City of Stacy Planning Report

TO: Stacy Planning Commission
FROM: Phil Carlson, AICP, Senior Planner; Dan Boyum, PE, City Engineer; Stantec
DATE: July 19, 2022
RE: Wheelhouse Commons Preliminary & Final Plat
ADDRESS: Falcon Avenue, NE quadrant with Stacy Trail
PID: 19.00004.20
OWNER: SNS Kramer Property LLC
APPLICANT: Steve Kramer
REQUEST: Preliminary & Final Plan Approval
ZONING: GB General Business

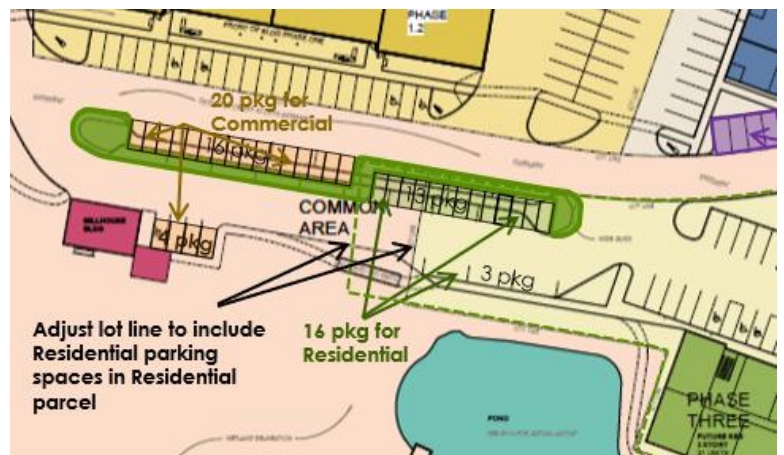
- 1) The plat follows closely the approved plans with one exception – Lot 3, the future residential parcel, was to be adjusted to allow the parking to be rearranged. A portion of the graphic in my February 8, 2022 report to the City Council is to the right, illustrating this recommended change. The submitted plat does not reflect this approved revision.

- 2) The applicant indicated that the residential development is some time off – maybe years – and that he intends to modify the site plan to accommodate all parking within the proposed Lot 3 as shown on the submitted plat, not the suggested revision. This is acceptable with the understanding that the PUD will need to be officially amended at that future date so that parking will stay within the lot and to accurately reflect what is actually developed, or else the plat will need to be revised.

- 1) If future residential development on Lot 3 has parking or other features that extend beyond the boundaries of Lot 3, the Planned Unit Development will be amended and approved by the City Council before development proceeds on that lot, or the plat will be revised to adjust the boundaries of Lot 3 to include all parking or other features on the residential development.
